**Re: Duplexs for Ahmet Tirkaki**  
**12100 Copper Ave NE**  
**Traffic Circulation Layout**  
Architect's Stamp 05-22-2022

The TCL submittal received 06-07-2022 is approved for Building Permit with. A copy of the stamped and signed plan will be needed for each of the building permit plans. Please keep the original to be used for certification of the site for final C.O. for Transportation.

DRAWING TITLE:  
TRAFFIC CIRCULATION PLAN

CIVIL101

1 TRAFFIC CIRCULATION LAYOUT

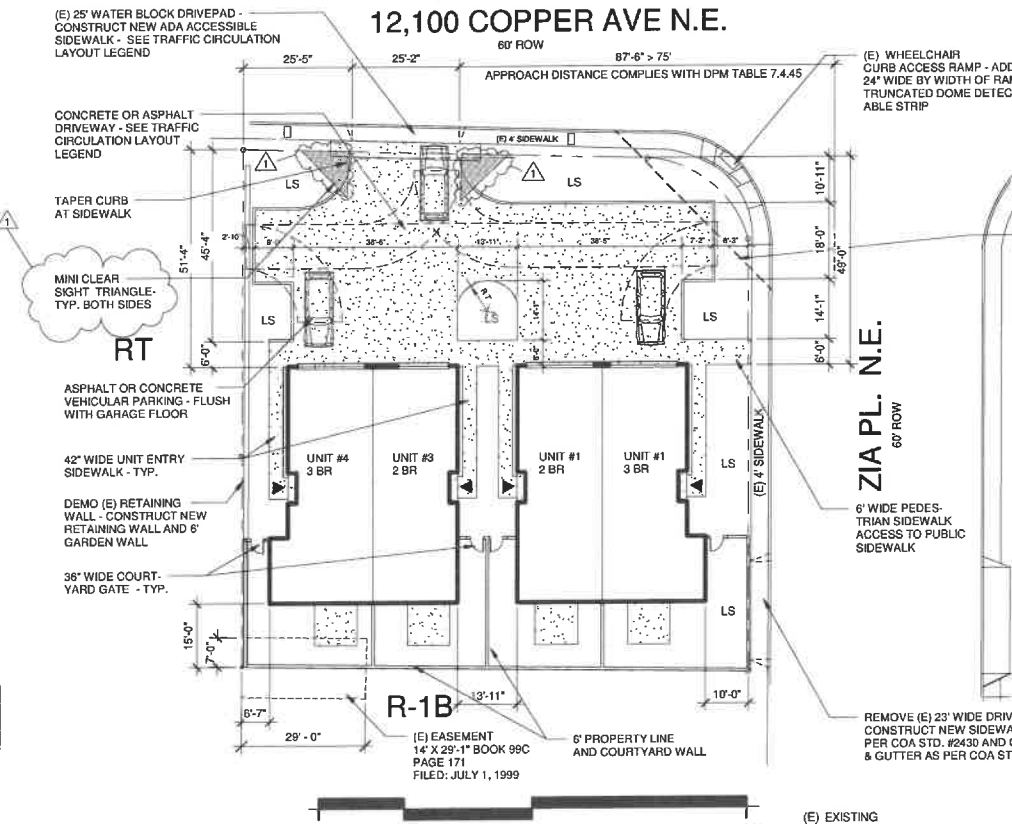
CONDITION OF C.O. (FINAL) APPROVAL:  
SIDEWALK EASEMENT FOR EXISTING 25'  
DRIVEPAD ACCESSIBLE SIDEWALK  
SHALL BE APPROVED,  
ACCEPTED AND IN PLACE. (NSF)
